**ROANOKE PLANNING AND ZONING AGENDA
500 S OAK ST
ROANOKE, TEXAS 76262**

RE: QuikTrip No. 1898 NEC of Bobcat & Hwy 377 - Preliminary Plat & Plans Review; 5/7/2026 Submittal

SUBJECT: Reconsider and take action on a Site Plan(SP-2026-03)

SITE PLAN

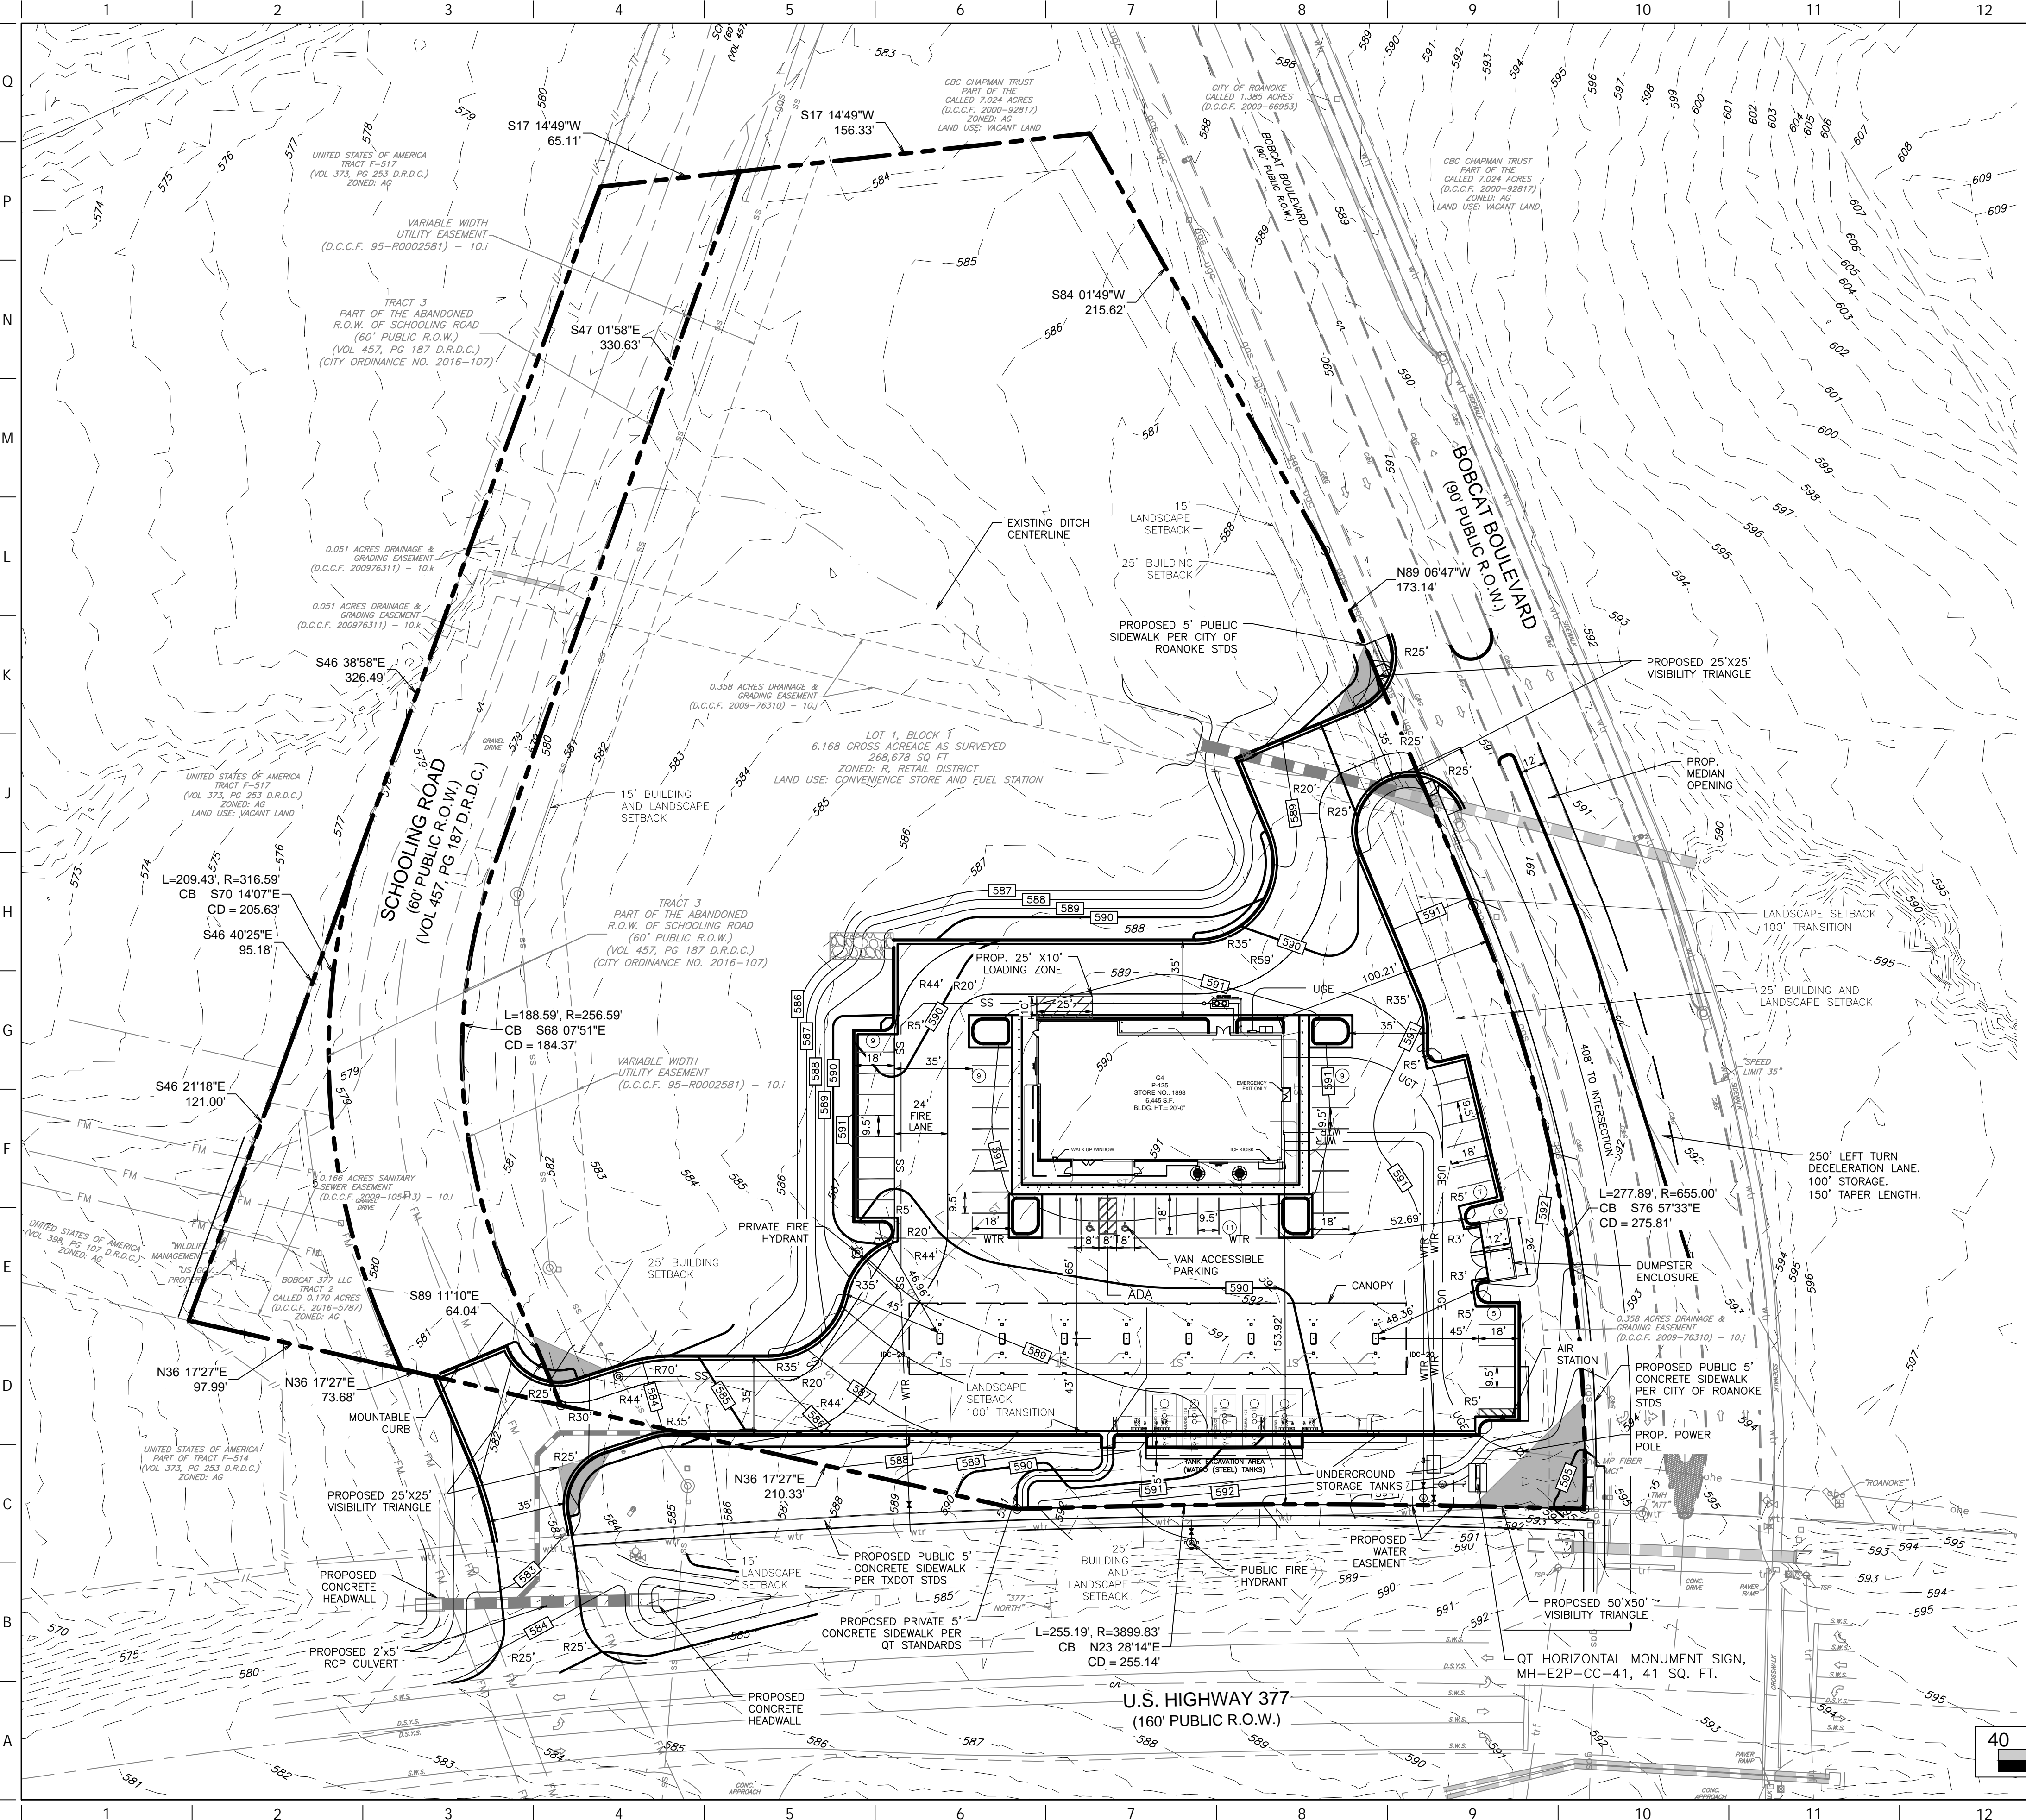
9. **TNP 1st Review:** Provide fire lane turning radii.
Westwood Response: See Site Plan and Utility plan.
TNP 2nd Review: Comment satisfied.
10. **TNP 1st Review:** Please revise proposed left turn lane on Bobcat Blvd in accordance with storage and deceleration requirements in Roanoke’s Technical Standards.
Westwood Response: Revised driveway spacing and left turn lane dimensions.
TNP 2nd Review: Comment satisfied.

- 1. Roanoke Zoning 1st Review:** Section 12.163 – Site Plan Submission Requirements
- Per 12.163(a)(8) Please show the existing zoning and existing/proposed uses on adjacent land.
 - Per 12.163(a) – Please provide proposed building heights and color building façade (elevations) as well proposed attached signage.
 - See 12.167 for items we consider when reviewing and provide updated plans accordingly.

- c. Please indicate all visibility triangles (this includes driveways) on the site plan. Additionally, I believe the monument sign and possibly the air station is located within the visibility triangle. Please relocate if necessary.

- a. Please revise the visibility triangle at the intersection of Bobcat and 377 to be 50'X50' per 12.807(a)(3). It is measuring at 50X50, so maybe just a mistake in the call out.
- b. Please revise visibility triangle at driveways to be 25'X25' per 12.807(a)(2). Both driveways require a visibility triangle.

- a. Provide distance of fuel canopy and **all improvements** from southern (Bobcat) boundary.
- b. Provide distance of fuel canopy and **all improvements** to western property boundary (377).
- c. Why are there 2 identified landscape buffers reflecting different setbacks along the western boundary, adjacent to 377 (a 25' and 15')?
- d. Sec 12.725(b) – minimum 25-foot landscape buffer adjacent to any arterial right of way (along 377 and Bobcat). Please revise as the southern boundary indicates a 15' setback where 25' applies.

Roanoke Planning 2nd Review: The building setbacks adjacent to Bobcat and 377 is 25-feet from all right-of way, essentially both of these property lines are "front" property lines. The building setback does not reduce after a certain distance like the landscape buffer does. Please revise.

4. Roanoke Zoning 1st Review: Sidewalk Width/Standards: Please provide the width of all sidewalks on site.

5. Roanoke Zoning 1st Review: Approach: Please remove gravel approach on the western driveway and replace with approach that meets city standards.

6. Roanoke Zoning 1st Review: Parking: Loading Space: 1 loading space is required, may not be located in a fire lane, must be clearly marked. Please revise.

7. **Roanoke Zoning 1st Review:** Dumpster & Dumpster Enclosure: Sec 12.771(b&g) – Please revise to reflect compliance with ordinance, provide dimensions. Preferably, the dumpster would be relocated to the rear of the primary building.

Westwood Response: Plans have been revised to show lot information. Building elevations and sign elevations are included with this submittal. Updated revised plans provided with this submittal.

Westwood Response: Sight visibility triangles added to site plan.

Westwood Response: Visibility triangles updated at both driveway entrances to be 25'x25' and 50'x50' at the 377 and Bobcat intersection property corner. Callouts updated as needed.

Westwood Response: Dimensions added to plans for canopy and all improvements to boundary lines. Landscape buffer is allowed to transition from 25' to 15' with a 100' transition length between the differing setback widths per code. Callout of transition shown on plans per planning staff's request.

Westwood Response: Building Setback to be 25' updated.

Westwood Response: Widths and standards added to callouts.

Westwood Response: Existing gravel approach label removed from plan.

Westwood Response: Loading space included and labeled on site plan.

Westwood Response: Dumpster has been relocated to be outside of the building setback. Dimension included.

Item #QT-MH15-E2P-CC-41

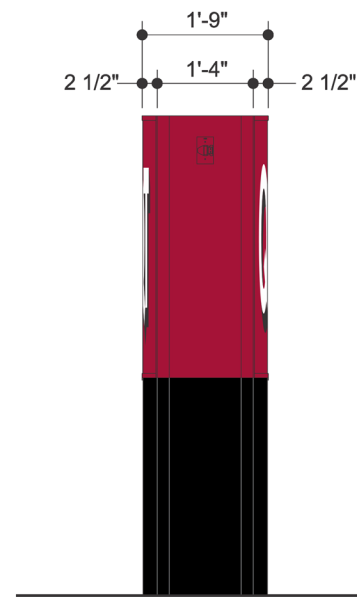
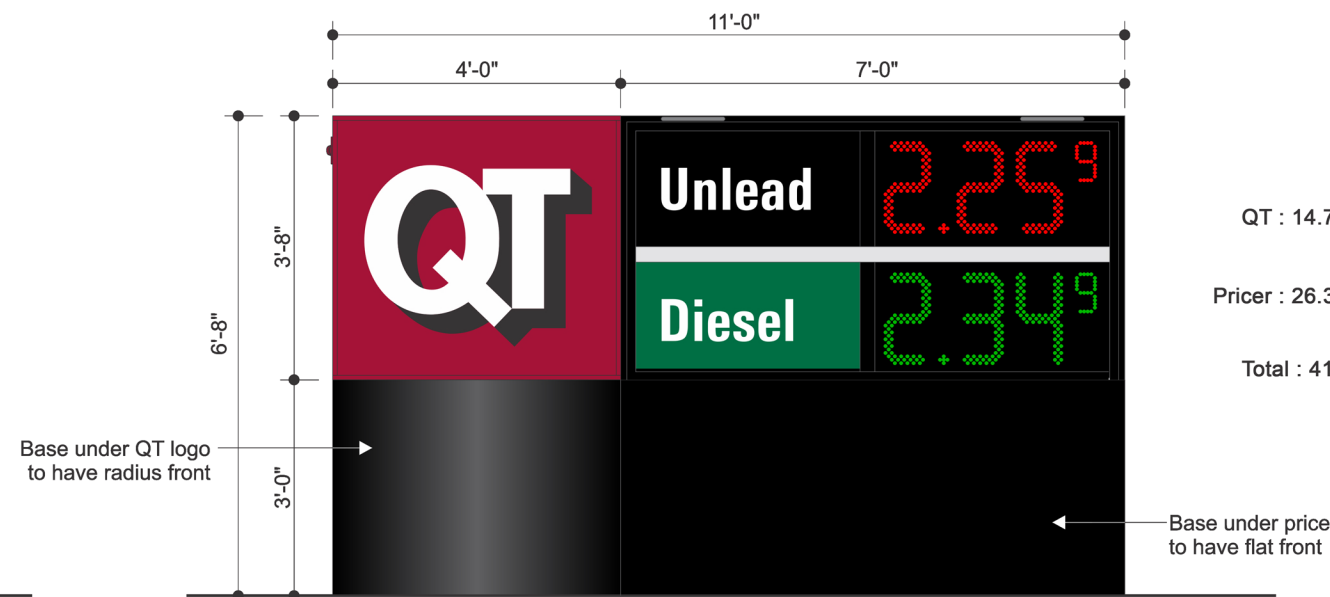
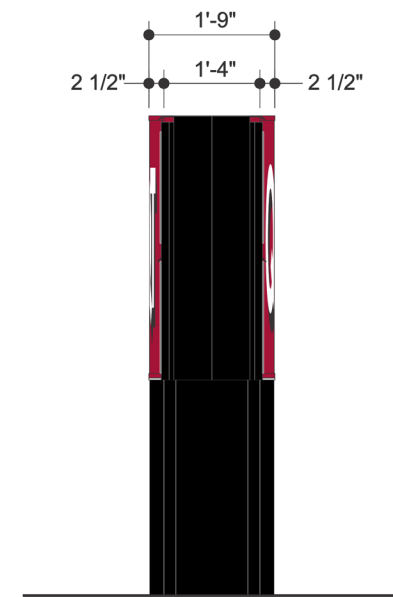
- a. See comment 1 and 2.
- b. Overall sign area from grade is approx. 89.21 square feet
- c. Maximum Surface area is 50 sf per side. Please revise.
- d. ECC max is 30%. Please call out the area of ECC portion separately as well as overall area calculations.

- a. Monument signs have a 10-foot setback from Right-of-Way. I'm measuring approx. 6.5 feet from 377.
- b. Businesses are permitted 1 attached sign per public street frontage (This project has a maximum of 2 attached signs permitted based on street frontage).
- c. Please provide the dimensions of all proposed signs. I'm measuring approx. 343 square feet pf signage, max area allowed per 12.855(b)
- d. Maximum Effective Area. Total effective area of attached signs shall not exceed the following: an attached sign or signs shall not exceed or cover more than fifteen percent (15%) of the façade area of a building face or area of the front of the leasable building space.

Westwood Response: Please revised monument sign elevations for new dimensions.

Westwood Response: Signage will remain and will be considered at City Council.
